Service Bulletin

Bulletin No. 2007-64
CMD 2007-04

QSD 2.0 Turbocharger Oil Supply Pipe

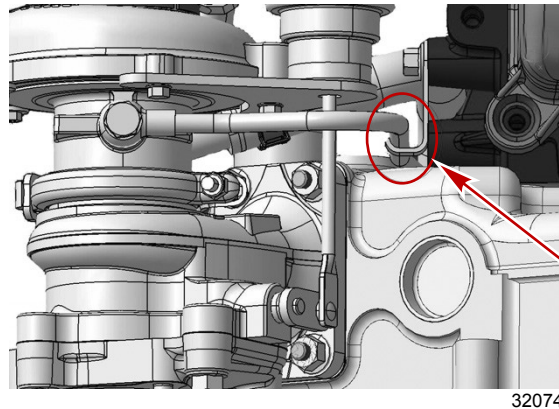
Look down at the top of the engine between the turbocharger and the rear of the cylinder head. Note where the turbocharger oil supply pipe bracket attaches to the rear of the cylinder head. If the bracket attaches directly to the oil supply pipe with a welded joint, it must be replaced. The correct turbocharger oil supply pipe has the bracket wrapping around the pipe.

Welded turbocharger oil supply pipe bracket—incorrect

Wrapped Turbocharger oil supply pipe bracket—correct

Early production QSD 2.0 engines may have been shipped with a turbocharger oil supply pipe that has an attachment bracket welded to the pipe. The welded joint may crack causing the pipe to leak. The oil supply pipe has been redesigned to use a bracket that wraps around the pipe.
